Teynham Parish Council Responding to planning application 23/505541/REM 'Frognal Place'

Prepared by: Teynham Parish Council Date: 3 February 2024

Responding to planning application 23/505541/REM

Image (above) taken from Frogal Lane looking southwest towards the A2 London Road, Teynham.

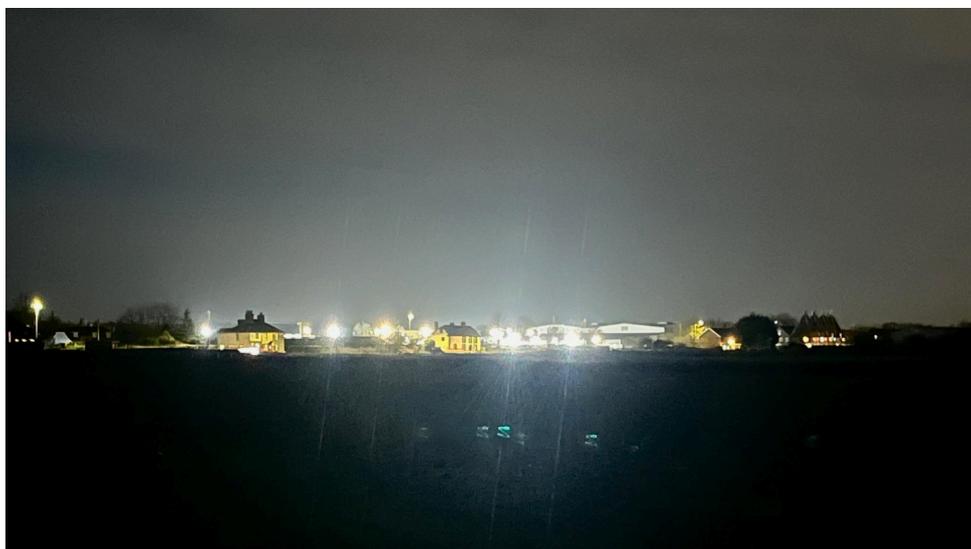
- 4.38. **Light pollution** — A recent large-scale commercial development on the London Road, Teynham (adjacent to the proposed site covered in this application) highlights the need for careful lighting design to prevent light pollution. In this example, significant light pollution illuminates the night sky and up to 1km in the local area.

- 4.37. **Street lights** — Permanent lighting should not impact the night sky or neighbouring residents. To enhance well being, street lights should create a warm glow with a colour temperature of c2700K.
